London Luton Airport Expansion

**8.118 Applicant's Response to Issue Specific Hearing 4
Action 7 - Update on Road Safety Audits**

**London Luton Airport Expansion Development Consent
Order 202x**

Report title:	Stage 1 Road Safety Audit Designer's Response- M1 Junction 10
Date:	November 2023
Document Reference and Revision:	TR020001/APP/8.118
Prepared by:	Neil Scott
On behalf of:	Luton Rising

Figure 2.1: Locations of Problems Identified within the Audit

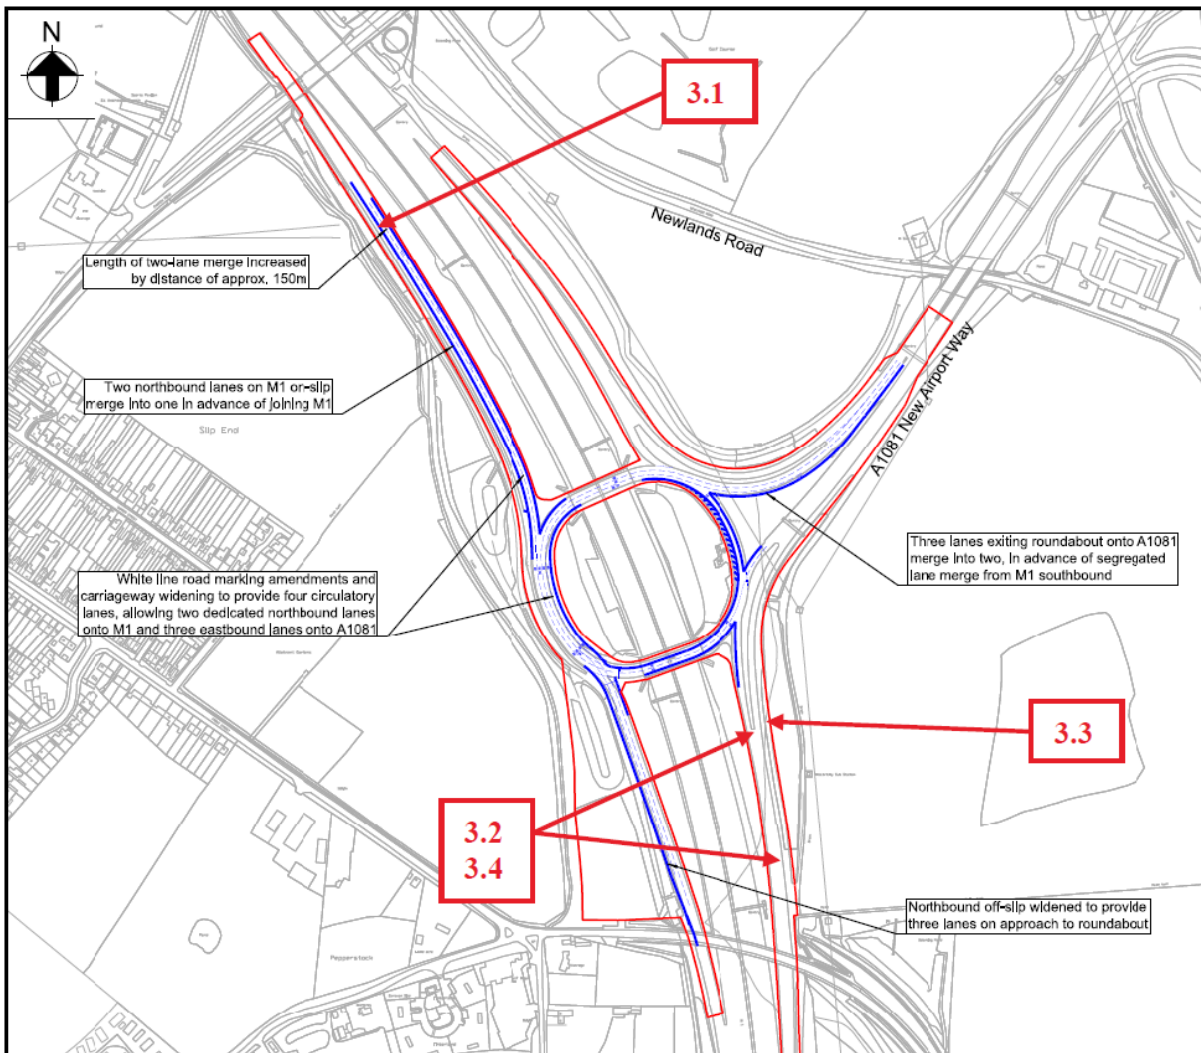
Ref.	RSA Problem	RSA Recommendation	Design Organisation Response	Overseeing Organisation Response	Agreed RSA Action
3.1	Drawing LLADCO-3C-ARP-SFA-HWM-DR-CE-0009 indicates that the length of the two-lane merge is to be extended by 150m. This may result in forward visibility of the merge point being compromised by an existing hidden dip in the northbound on-slip. This problem increases the risk of side swipe and loss of control type collisions.	Ensure that sufficient forward visibility of the merge is maintained.	Accepted. Forward visibility would be checked at the detailed design stage to ensure that appropriate visibility of the merge is maintained.	National Highways agree with the RSA. Traffic on the slip will be visible but the designer has agreed to checks.	Forward visibility would be checked at the detailed design stage to ensure that appropriate visibility of the merge is maintained.

3.3	<p>In Phase 2a and Phase 2b a two lane segregated left turn from the A1081 onto the M1 southbound slip road has been proposed. The existing southbound lane from the M1 J10 roundabout is proposed to join the segregated lanes with a short length of off-side merge. No details regarding infrastructure or stopping sight distances have been provided. Items such as VRS and signs between the segregated left turn lanes and off-side merge may obscure visibility for road users. This issue may increase the risk of side swipe, shunt, and loss of control type collisions. This</p>	<p>Provide sufficient intervisibility between the merge and segregated left turn lanes.</p>	<p>Accepted. See above response to Item 3.2 regarding the design or removal of the merge. If the exit off the circulatory is retained, there is scope to amend the alignment of the segregated left turn and separating island in order to accommodate potential VRS, signage and visibility requirements. This would be addressed at the detailed design stage.</p>	<p>National Highways agree with the RSA.</p> <p>It would be interested to explore the potential for closing the eastern circulatory or S/B merge exit as mentioned. That could remove a couple of issues, but signing for route finding would be key.</p>	<p>Amend the alignment of the segregated left turn and separating island in order to accommodate potential VRS, signage and visibility requirements. This would be addressed at the detailed design stage.</p> <p>The opportunity to close the eastern circulatory or southbound merge will be considered at the detailed design stage.</p>

Figure 2.1: Locations of Problems Identified within the Audit

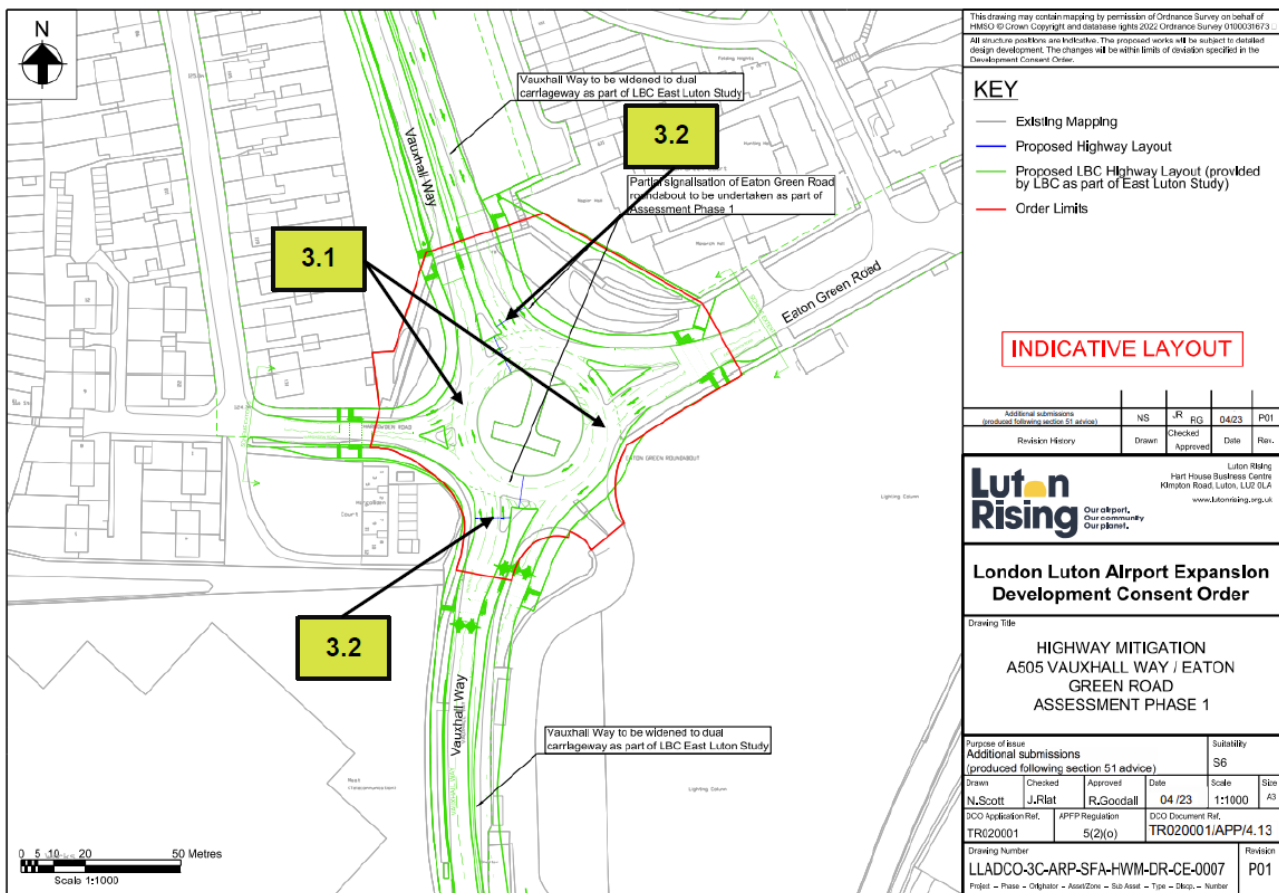
Ref.	RSA Problem	RSA Recommendation	Design Organisation Response	Overseeing Organisation Response	Agreed RSA Action
3.1	The stacking distance between successive signal stop lines is quite short, which could lead to vehicle queues extending across the Harrowden Road and Eaton Green Road entries to the roundabout. As a result, collisions could occur as road users attempt to weave through queues or change lane suddenly.	It should be ensured that the road layout and traffic signalling strategy is suitable to prevent vehicles queuing across entry arms to the roundabout.	Accepted. The operation of the signals would be optimised to ensure the efficient operation of the junction and would include consideration of queue lengths within the circulatory carriageway of the roundabout.	Design Response is accepted.	RSA recommendation to be adopted as part of the detailed design.

3.2	The widening to three lanes on the approaches to the junction could increase the likelihood of the primary signals being masked by high sided vehicles. If a red signal is not clearly visibly to road users, there could be an increased risk of overshoot collisions or accidents involving sudden and late braking, such as rear-end shunts.	High-mounted duplicate primary signals should be provided on the Vauxhall Way approaches to the junction.	Accepted. The provision of high-mounted signals would be considered at the detailed design stage.	Design Response is accepted.	RSA recommendation to be adopted as part of the detailed design.

Figure 2.1: Locations of Problems Identified within the Audit

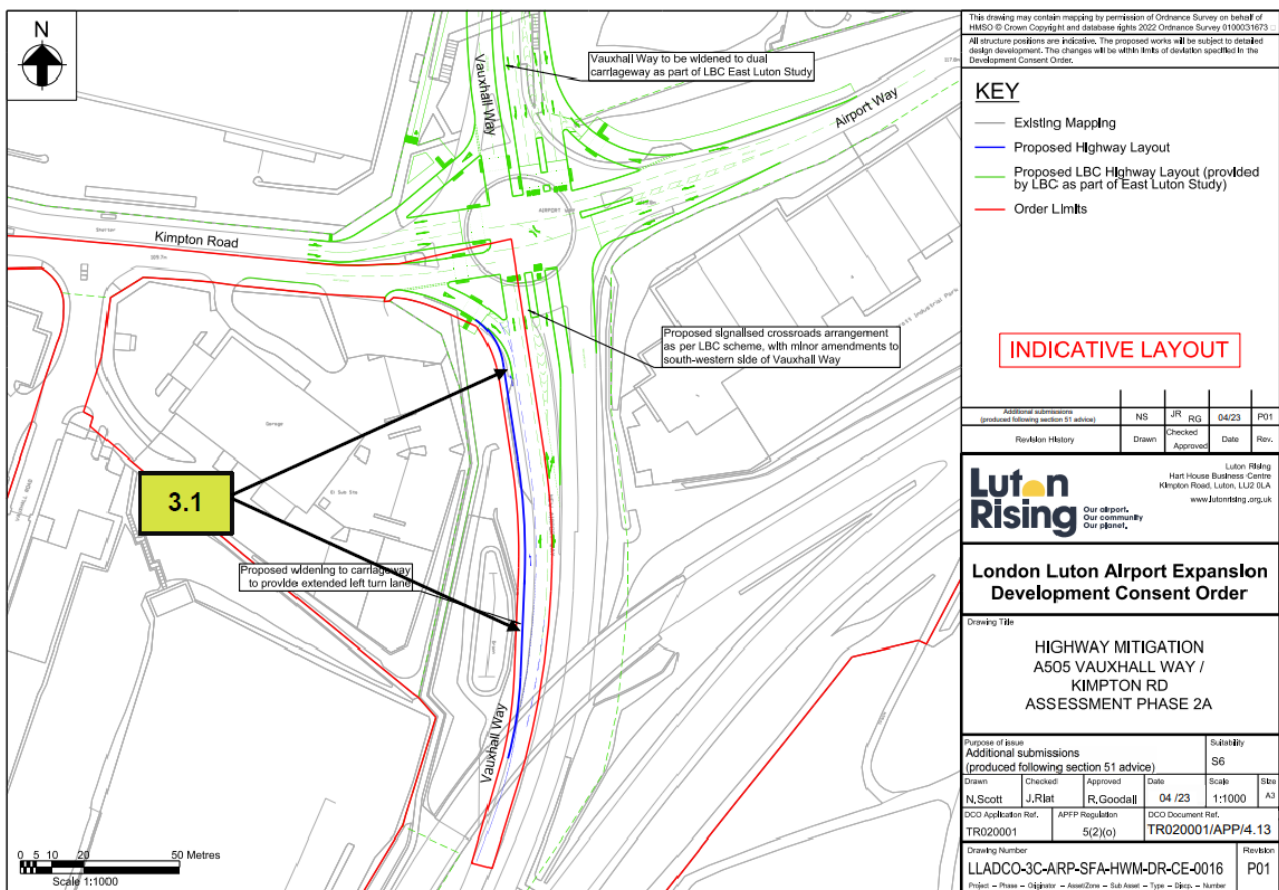
Ref.	RSA Problem	RSA Recommendation	Design Organisation Response	Overseeing Organisation Response	Agreed RSA Action
3.1	There are lamp columns and trees within the verge that will be closer to the edge of carriageway when the road is widened. A temporary vertical concrete barrier is also present, but it is not clear whether this will be retained. If not, the lamp columns and trees could present a roadside hazard to road users if they lose control and collide into the objects. Injuries could be serious if vehicles are brought to an abrupt halt or redirected violently.	A suitable vehicle restraint system should be provided, unless the lamp columns are replaced by passively safe systems and any mature trees removed that will be close to the edge of carriageway.	Accepted. This would be addressed at the detailed design stage.	Design Response is accepted.	RSA recommendation to be adopted as part of the detailed design.

Figure 2.1: Locations of Problems Identified within the Audit

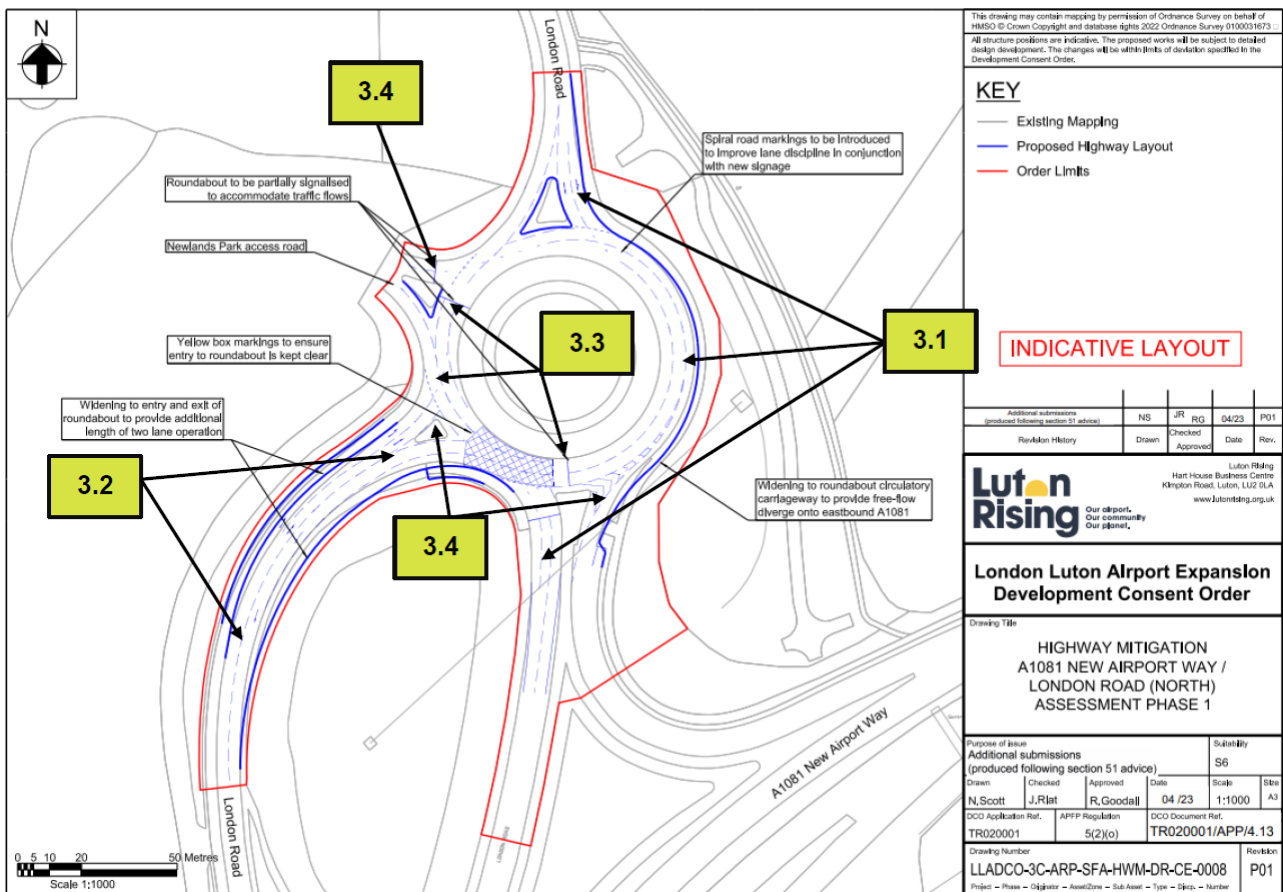
Ref.	RSA Problem	RSA Recommendation	Design Organisation Response	Overseeing Organisation Response	Agreed RSA Action
3.1	Road users may not be able to anticipate which lanes to use to reach their intended destination. For example, on the A1081 approach, road users may use the middle lane to reach London Road (north) rather than the designated offside lane. On the London Road southbound approach, road users may use the offside lane to reach the A1081 (which they can currently), instead of using the nearside lane only. If road users find that they are in the incorrect lanes, side swipe and lane change collisions could occur.	Lane destination signs and road markings should be provided at strategic locations to inform road users of the correct lanes to use.	Accepted. Lane markings and signage would be provided to clarify which destinations are reached from each approach lane. This would be addressed at the detailed design stage.	Design Response is accepted.	RSA recommendation to be adopted as part of the detailed design.

Ref.	RSA Problem	RSA Recommendation	Design Organisation Response	Overseeing Organisation Response	Agreed RSA Action
3.3	The stacking distance between successive signal stop lines is quite short, which could lead to vehicle queues extending across the London Road southern entry to the roundabout. As a result, collisions could occur as road users attempt to weave through queues or change lane suddenly.	It should be ensured that the road layout and traffic signalling strategy is suitable to prevent vehicles queuing across entry arms to the roundabout.	Accepted. The operation of the signals would be optimised to ensure the efficient operation of the junction and would include consideration of queue lengths within the circulatory carriageway of the roundabout.	Design Response is accepted.	RSA recommendation to be adopted as part of the detailed design.

3.4	The widening of the roundabout could make crossing movements more hazardous for pedestrians and cyclists, especially at times of high vehicle flows (peak times) or when speeds could be higher at off-peak times. This could be a particular issue on the London Road southern arm and on the A1081 exit arm. On the Newlands Park access entry to the roundabout, the position of the signal stop line could make it difficult to provide a crossing point. Vulnerable road users could be at increased risk of being struck by vehicles under such circumstances.	It should be ensured that the pedestrian and cycle crossing points will be safe to use (for example, controlled crossings may be beneficial at some locations).	Noted. The proposed realignment on the A1081 exit arm increases the crossing distance by approximately 1.0m and could be reduced at the detailed design stage to minimise any additional crossing distance. The pedestrian demand on the London Road (south) exit arm is likely to be very low, and the proposed signalisation of the A1081 arm should create gaps in the traffic for pedestrians to cross. In addition, the widening to the London Road exit is c1.5m and would only add c.1 second to the crossing time for pedestrians.	Design Response is noted. Recommend that non-motorised user demand is reviewed as part of the detailed design.	RSA recommendation is noted and overseeing organisation comment accepted.

Ref.	RSA Problem	RSA Recommendation	Design Organisation Response	Overseeing Organisation Response	Agreed RSA Action
			<p>The position of the stop line at the exit from Newlands Park would be adjusted to accommodate a pedestrian crossing at the detailed design stage.</p>

Figure 2.1: Locations of Problems Identified within the Audit

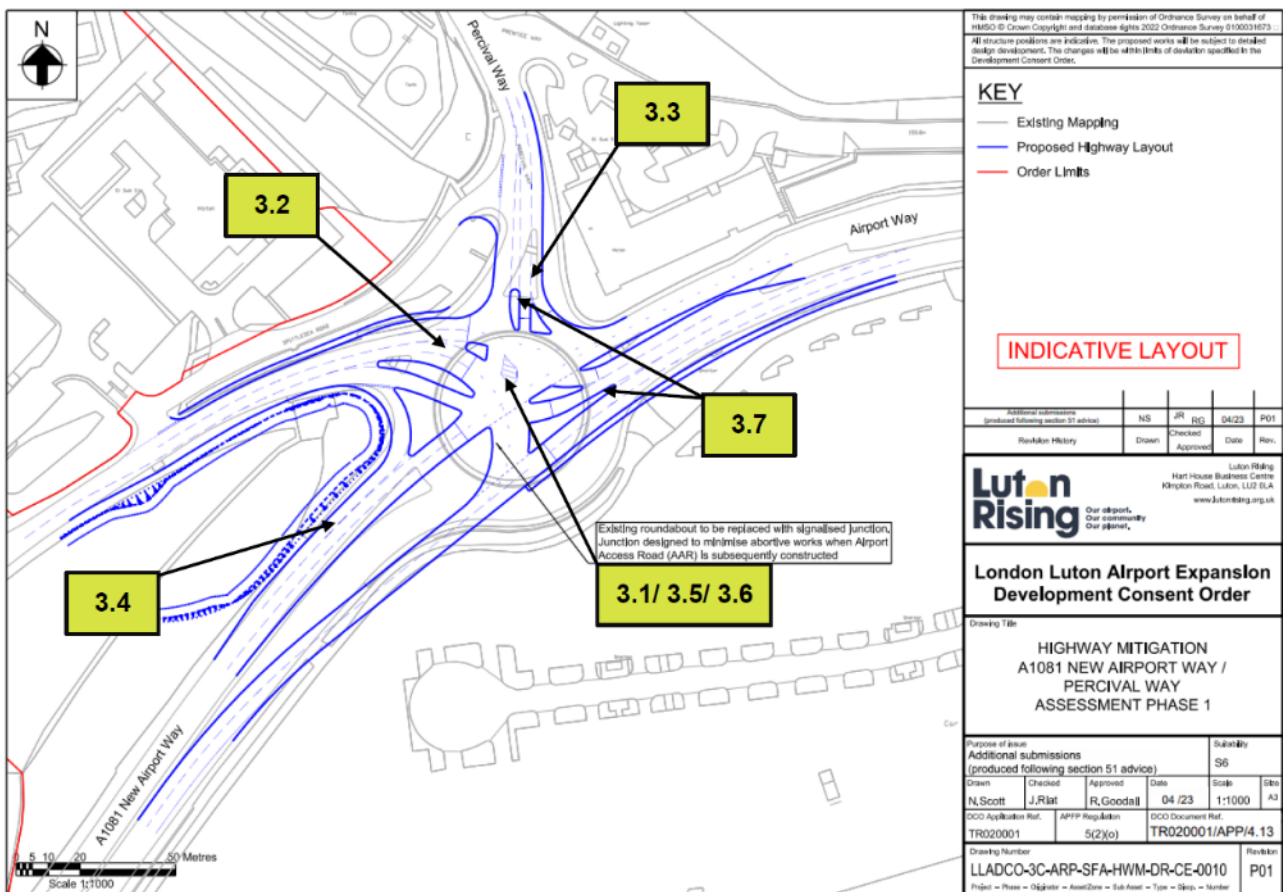
Ref.	RSA Problem	RSA Recommendation	Design Organisation Response	Overseeing Organisation Response	Agreed RSA Action
3.1	It was noted that the existing roundabout for New Airport Way and Percival Way is on a steep gradient which slopes away from the north side. With the introduction of the signalised junction there could be a level difference between each approach, which could create an adverse camber for vehicles turning at the junction. This could increase the risk of loss of control collisions and could cause larger, high sided vehicles to turn over.	The levels should be checked for each approach ensuring a level junction platform with no adverse cambers for vehicle turning movements.	Accepted. It is accepted likely that some regrading would be required on the approaches to and within the junction. This would be addressed at the detailed design stage.	Design Response is accepted.	RSA recommendation to be adopted as part of the detailed design.

Ref.	RSA Problem	RSA Recommendation	Design Organisation Response	Overseeing Organisation Response	Agreed RSA Action
3.3	The vertical alignment for Percival Way on the approach to the junction is on a steep downhill section. With the introduction of the signal control there could be more sudden braking movements such as when the lights change from green to red. This combined with being on a downhill section could increase the risk of loss of control and subsequent shunt and junction overshoot collisions.	A level dwell area of suitable length should be created for this arm of the junction.	Accepted. See response to 3.1.	Design Response is accepted.	RSA recommendation to be adopted as part of the detailed design.

3.5	With numerous lanes and splitter islands, road users turning at the signalised junction might have difficulty manoeuvring into the correct lane for their required destination. These potentially late lane swapping manoeuvres could increase the risk of side swipe collisions with other users. Furthermore, they might get confused and turn into the incorrect	At detailed design stage appropriate signing, lining and bollards should be installed at the junction to guide users to the correct lanes for their desired destination. Signal phasing should be reviewed ensuring minimal conflicts between opposing traffic	Accepted. Appropriate signage, road markings and bollards would be provided at the detailed design stage to reinforce appropriate manoeuvres throughout the junction.	Design Response is accepted.	RSA recommendation to be adopted as part of the detailed design.

3.7	It is not known at this stage if there are going to be any controlled crossing facilities at the proposed signalised junction. It is noted that for Airport Way and Percival Way there are existing shared footway/ cycleways and uncontrolled crossing facilities which link to a nearby hotel and car park area. With the new multilane signalised arrangements with greater crossing distances this could increase the risk of collisions with pedestrians and cyclists.	Pedestrian and cyclist movement should be reviewed around the junction and appropriate controlled crossing facilities should be installed where required such as Toucan crossings. These should also be compliant with the latest cycling guidance, such as LTN 1/20.	Accepted. There is flexibility within the junction design to accommodate crossing facilities on existing desire lines and this would be considered at the detailed design stage.	Design Response is accepted.	RSA recommendation to be adopted as part of the detailed design.

Figure 3.1: Swept Paths - A1081 New Airport Way / Airport Way

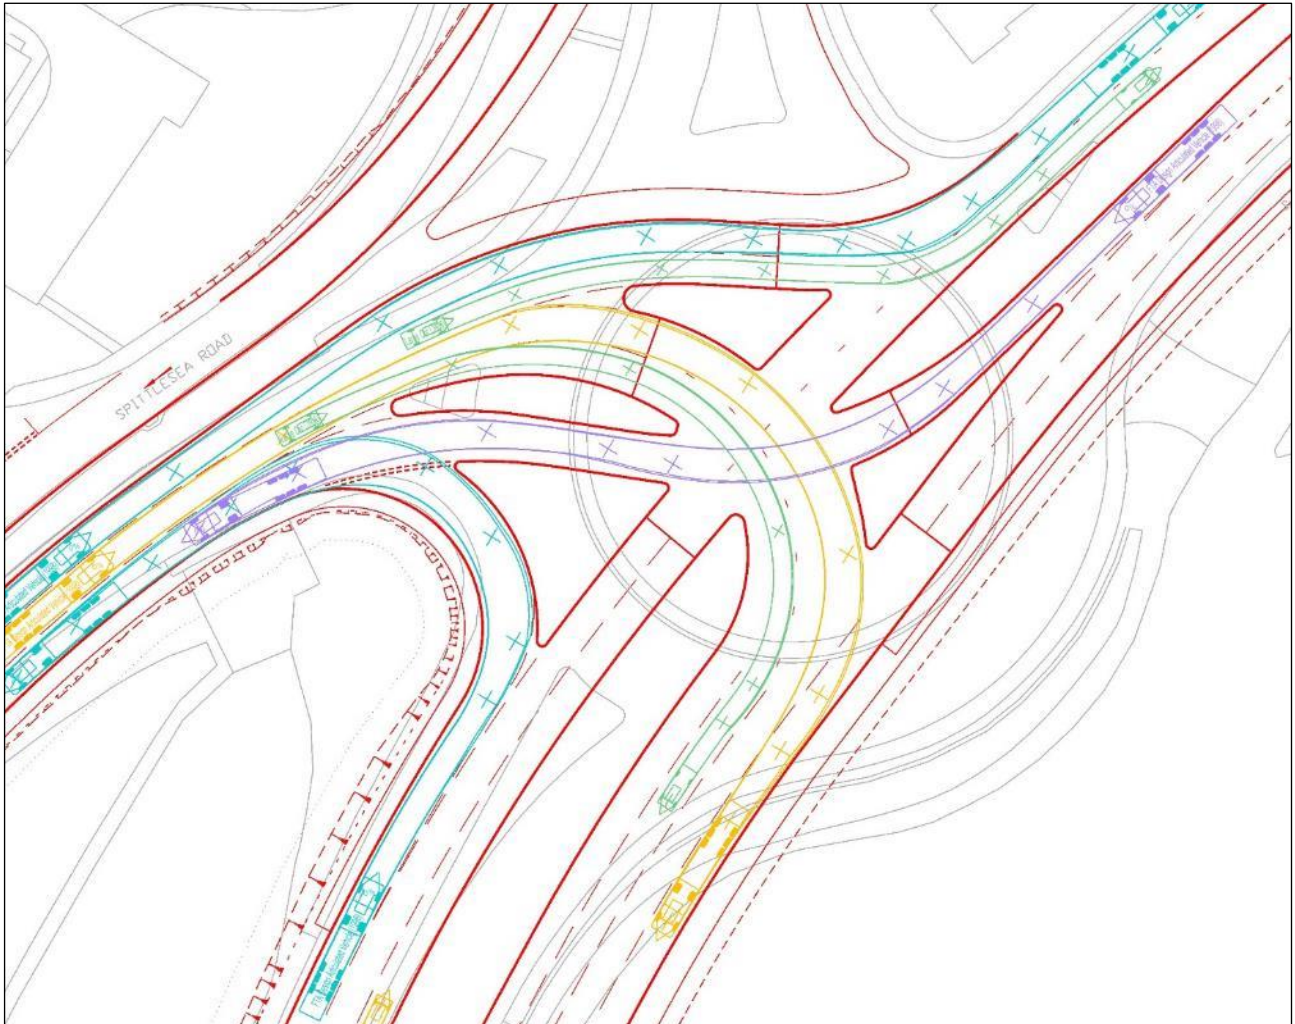
- 3.2.1 Figure 3.1 above shows the swept path analysis for 16.5m articulated HGVs and large cars at the signalised junction between A1081 New Airport Way, Airport Way and Percival Way.
